19/0534/FUL - Site off Alphinbrook Road and Hennock Road North, Marsh Barton Trading Estate

(Travis Perkins (Properties) Limited)

06 June 2019

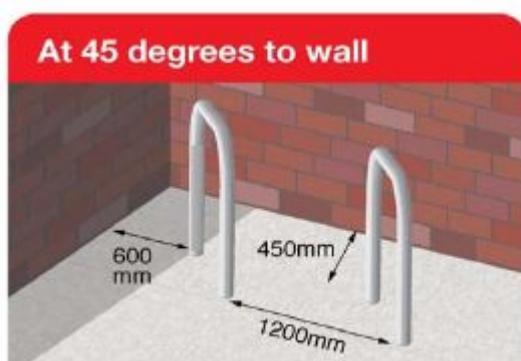
b) **Location of cycle parking:** Access to the proposed cycle parking shelter at Plot 1 is via a route of approx. 6m width that is bounded between the line of 27 car spaces and a storage area, and the shelter itself is close to two goods roller shutter doors.

There is likely to be conflict between cycles, cars manoeuvring to and from the parking spaces, pedestrians walking to and from parked cars and goods movements around the two goods door entrances which are adjacent to the cycle parking shelter and the storage area.

It is recommended that the cycle parking is relocated to a larger and more accessible position, for example at the opposite end of the row of 27 car parking spaces, where it would be visible from the main entrance on Hennock Road North.
